Road Safety Audit Report

**Incorporating
Stage 1 Completion of Preliminary Design**

Proposed Development Access off the A259 New Road, Rustington

Client:
Commercial Development Projects Ltd

Audit Item No.	Audit Team Observation	Audit Team Recommendation	Design Team / Scheme Response
A.4.2	PROBLEM <i>No dropped kerb crossing points</i>

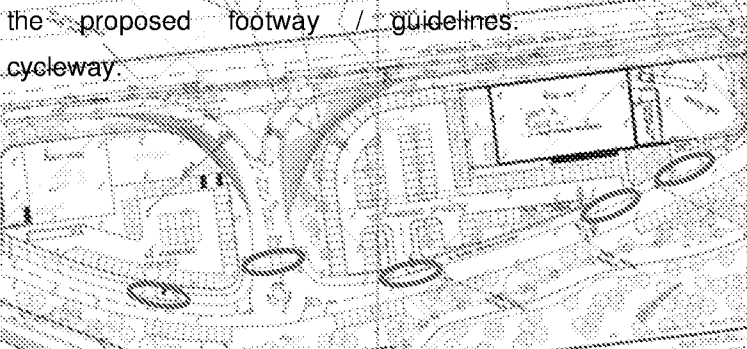
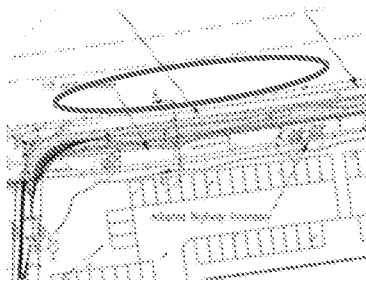
Accident Type <i>Pedestrian trip / cyclists fall</i> Location <i>Footway / cycleway through the site</i> The scheme drawings do not identify that dropped kerb crossing points are to be provided along the length of the proposed footway / cycleway. It is recommended that dropped kerb crossing points with tactile paving are provided in accordance with guidelines. Refer to Redwood Partnership response dated 15th March 2017, Ref 3167D5 
A.5	ROAD MARKING, SIGNS, LIGHTING, DRAINAGE AND SERVICES
A.5.1	PROBLEM <i>Faded road markings</i> Accident Type <i>Vehicle collisions</i> Location <i>Alongside proposed footway / cycleway</i> The A259 road markings alongside the proposed footway / cycleway appear to be faded. This is an existing issue, however observations show that the recently constructed scheme has re-laid markings adjacent to the works. There will therefore be a gap in the markings which could confuse drivers. It is recommended that the A259 road markings are re-laid alongside the entire scheme. Refer to Redwood Partnership response dated 15th March 2017, Ref 3167D5
